MEMORANDUM

RE: Ex Parte Communications in Connection with
Docket No. EERE-2016-BT-STD-0022
Energy Conservation Standards for Uninterruptible Power Supplies: Pre-Publication
Energy Conservation Standards Final Rule

Enc: Graphs of UPS Efficiency Data versus Current and Pre-publication Standards

Date: July 5, 2017

Voltage and Frequency Independent

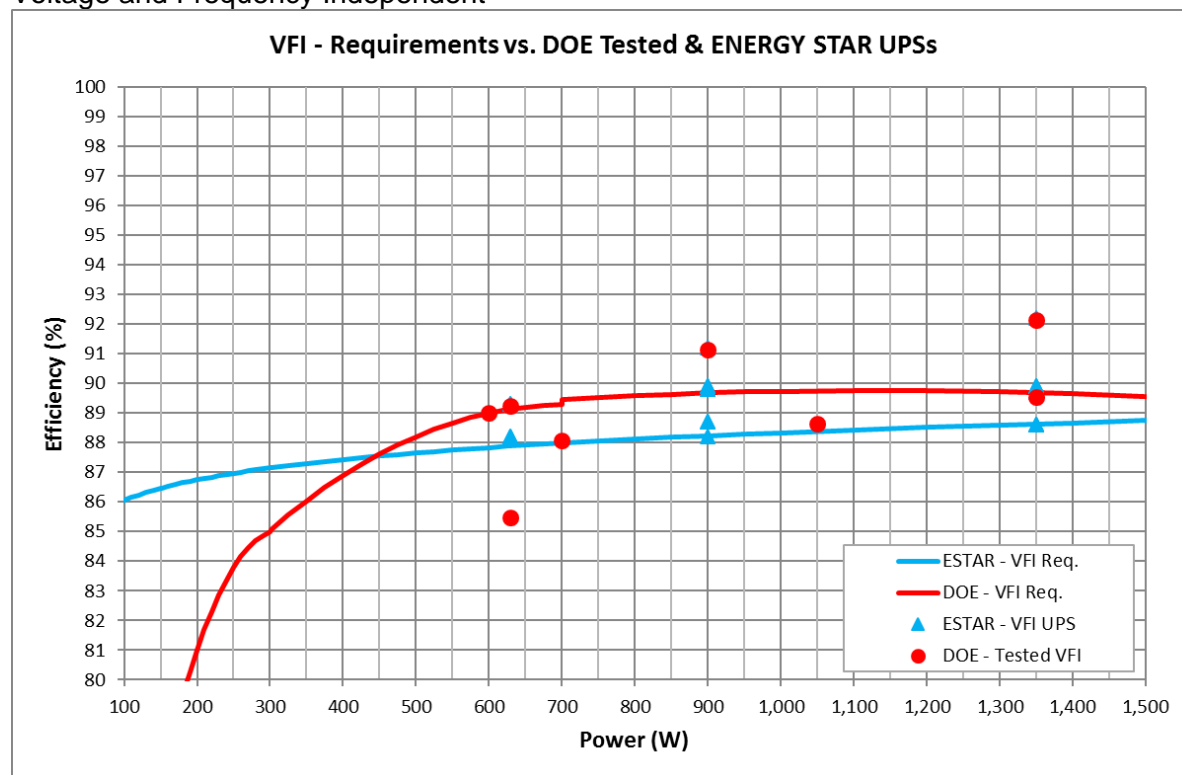
NEMA members continue to be strongly concerned that the pre-publication standards for VFI and VI UPS are too stringent and will eliminate too many, or all, products available today. Graphs of the pre-publication standards against the data set from the TSD were reviewed, and are attached to this memorandum. NEMA members noted their concerns for VFI products for the 300W-700W product class in light of the pre-publication standards. DOE noted on the NEMA graph provided two or three data points for products that fall on the efficiency curve's line and that those count as compliant designs. NEMA members disagreed, and stated that they do not stake their reputations and financial liability (risk of enforcement fines) on products that just meet the minimum. Instead, overdesign is needed to account for manufacturing variation and instrument variation during testing. As such, in the eyes of NEMA members, there are NO VFI products below 900W today that can pass the pre-publication standards and all products for those wattages must be redesigned. The DOE's opinion that there are products that do pass (barely) illustrates NEMA's concern that this impact is not accurately assessed in the TSD analysis. Manufacturers need margin to allow for manufacturing and test equipment variations. In practical terms for manufacturers, a minimum efficiency curve which is drawn through one or more product's data points actually cuts those products out. Only products that fall above the curve can be considered passing future standards, when variation margin is taken into account. The practical impact of this is that it would cause a low or non-existent selection of VFI products below 700W, which would force consumers who need this type of product to buy larger capacity, more expensive units, and then operate them at a low load-point which would in turn yield lower energy savings and greater consumer impact than reflected in the TSD analyses.

Voltage Independent

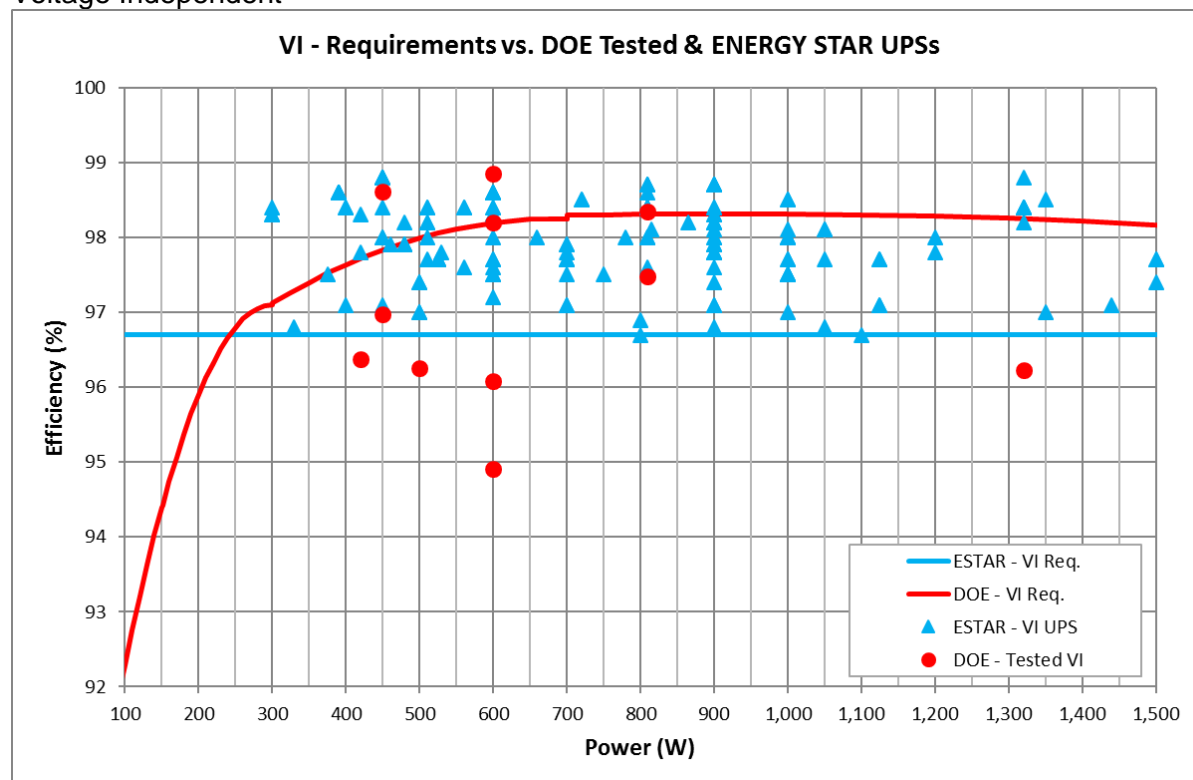
A similar challenge exists for VI products, though not as acute. Again, those products whose data points fall exactly on the curve are considered as non-passing in the eyes of NEMA members, and that impact should be accurately factored into analyses.
